SUBJECT: COMANCHE PEAK NUCLEAR POWER PLANT, UNITS 3 AND 4  
DOCKET NUMBERS 52-034 AND 52-035  
RESPONSE TO REQUEST FOR ADDITIONAL INFORMATION NO. 2994

**Response to Request for Additional Information No. 2994 (CP RAI #108)**  
**Question 03.08.04-1 (Public Version)**

**QUESTION NO.: 03.08.04-1**

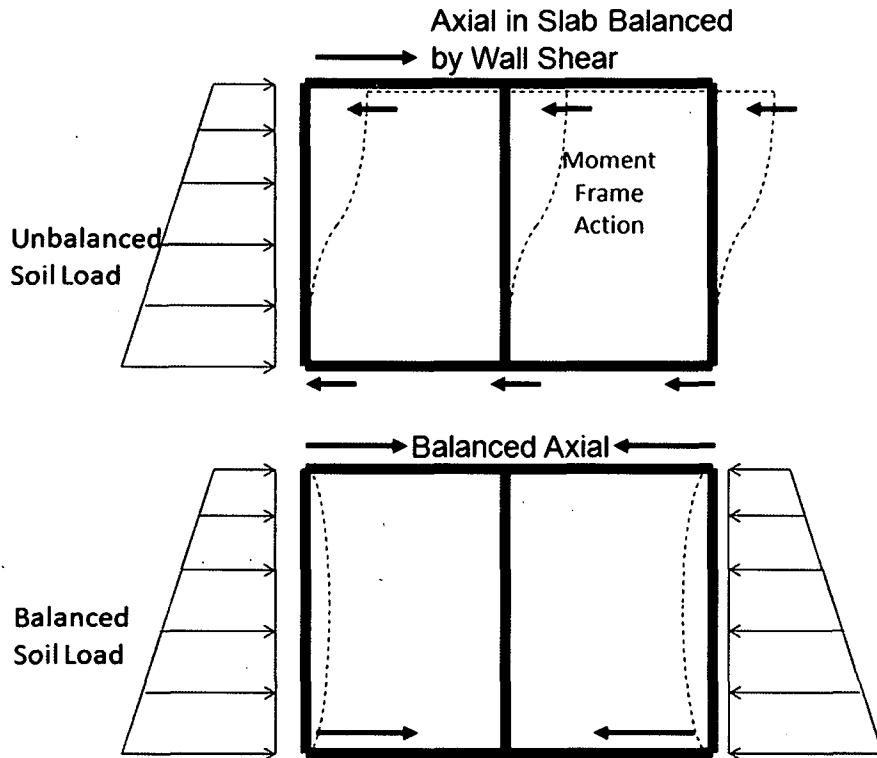
The axial force in the statement quoted from Subsection 3.8.4.4.3.1 is horizontal force within the slab which is axial in the transverse direction of the tunnel due to unbalanced soil load on the exterior walls.

This statement is illustrated in the figure below showing only the horizontal, at-rest soil pressures on the sides of the tunnel. In the top figure, the axial force in the roof and mat slab is unbalanced by soil pressure on the other side. The axial force in the roof translates to out-of-plane shear in the walls,

which causes the moment frame action of the tunnel. In the bottom figure, the soil pressure on both sides balances the axial force in the roof and mat slab.

FSAR Subsection 3.8.4.4.3.1 has been revised to clarify the direction of the axial forces.

Tunnel Segment 1 including surrounding soil layers and fill beneath

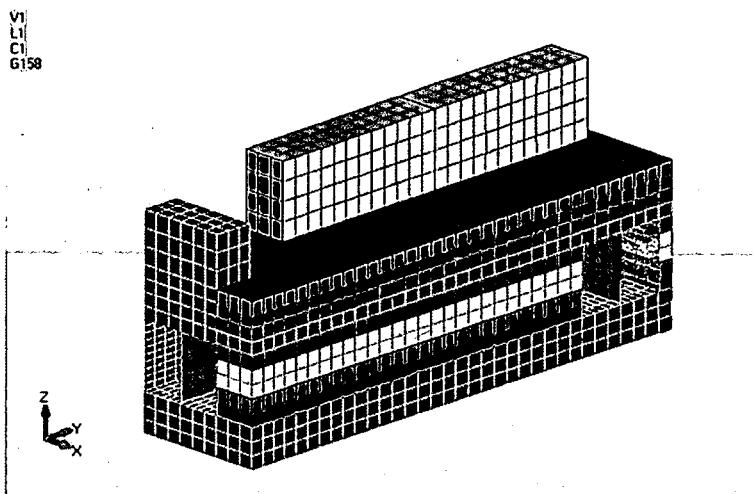
- (a) The first sentence of the above quoted paragraph discussed only the dynamic forces oriented parallel to the length of the tunnel segment. Provide a similar description for dynamic forces perpendicular to the length of the tunnel segment.
  - (b) Provide detailed information that shows how the static and dynamic soil pressure is calculated in accordance with ASCE 4-98.
-

- (a) For dynamic forces acting perpendicular to the length of the tunnel, the roof acts as a diaphragm that transfers loads to the interior and exterior walls. The tunnel walls and slabs behave similar to a moment frame causing out-of-plane bending in these elements. The dynamic soil and structural forces are transferred through the tunnel walls, into the mat slab, and then into the concrete fill and supporting limestone.

- (b) The static soil pressures are not calculated using ASCE 4-98. The static soil pressures were calculated using at-rest pressures with  $K_o = 0.47$ . This is the same as the at-rest pressure coefficient given in Figure 2.5.4-243 of the FSAR. The design also considered the load from the overburden pressure and the soil compaction pressure.

The seismic soil pressures are calculated directly in the SASSI analyses and are applied as equivalent static pressures in the ANSYS design model. The equivalent static seismic soil pressures applied in the ANSYS design model are shown to be conservative when compared to the calculated elastic solution used in ASCE 4-98 based on J.H. Wood, 1973 and the enveloped SASSI results. For calculation of the seismic soil pressures based on ASCE 4-98, the soil acceleration was taken as 1.5 times the ZPA of the spectrum at El. 782' (bottom of fill concrete) for tunnel segments 1 and 3 and 2.0 times this ZPA for tunnel segment 2. The value of  $C_v$  was taken equal to 0.99. The soil unit weight was taken as 125pcf.
